Public Notice of Application for Permit

PUBLIC NOTICE DATE: September 4, 2008
EXPIRATION DATE: September 18, 2008
REFERENCE NUMBER: POA-1986-106-M5
WATERWAY: Lynn Canal

PUBLIC NOTICE REVISION

**PROPOSED ROCK BREAKWATER
 SITE LOCATION MAP
 REF. #POA-1986-106-M5**

PROPOSED ROCK BREAKWATER
SITE CROSS SECTIONS
REF. #POA-1986-106-M5

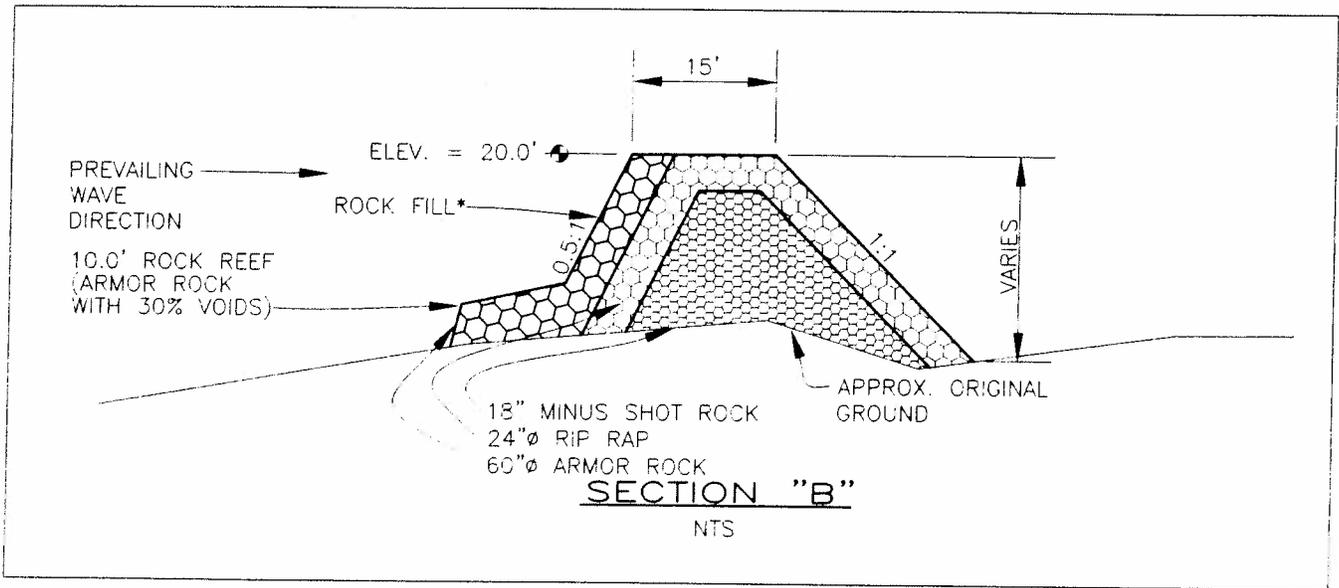
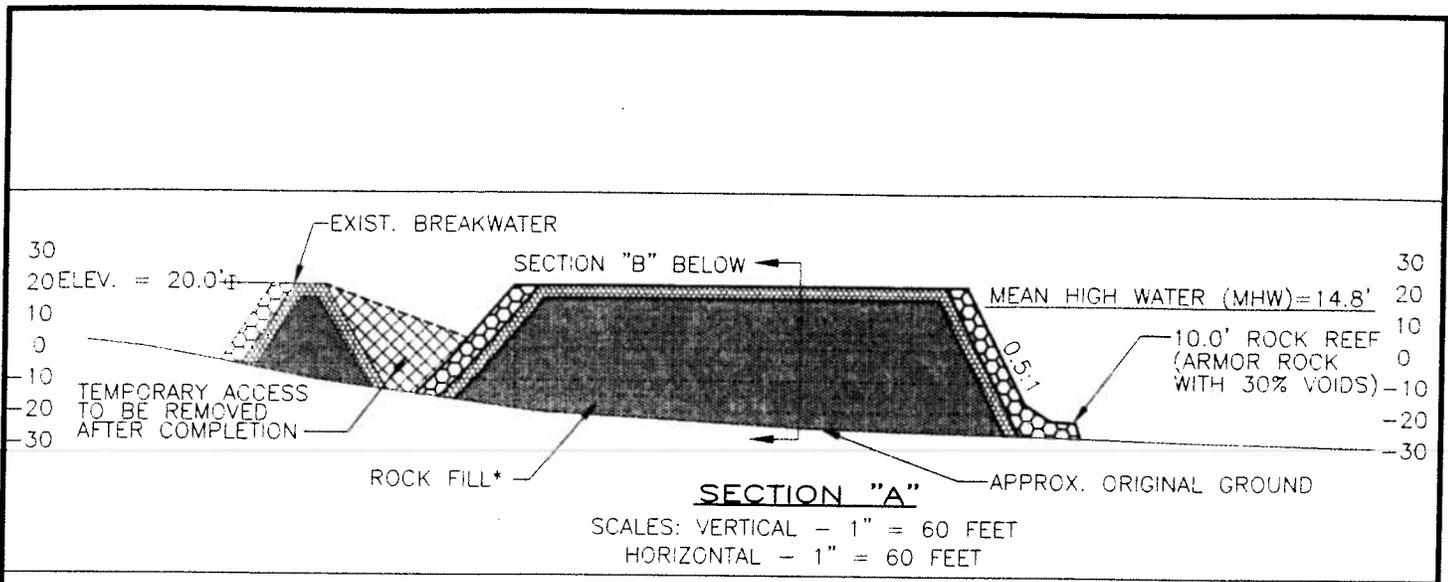
The applicant has amended the design of the proposed breakwater extension, and now proposes to construct it in accordance with the enclosed plans (Sheets 1 through 2 of 2 dated September 2, 2008). These replace Sheets 1 through 2 of 2 dated March 18, 2008, as contained in the August 5, 2008, Public Notice. There is no appreciable change to its overall footprint size. Changes to the design would be:

1. A larger opening between the existing breakwater and the final configuration of the proposed breakwater extension;
2. A steeper slope on the upper part of the structure and a gentler slope on the lower part of the structure on the Lynn Canal side of the proposed breakwater extension;
3. Its composition, per this amended design, would consist of an inner core of 18" minus shot rock (4,800 cubic yards), covered by a layer of 24" minus shot rock (3,800 cubic yards), with an armoring of 60" armor rock on the seaward facing side of the proposed breakwater (3,400 cubic yards); and,

4. The proposed breakwater centerline would be moved slightly toward the northeast several feet.
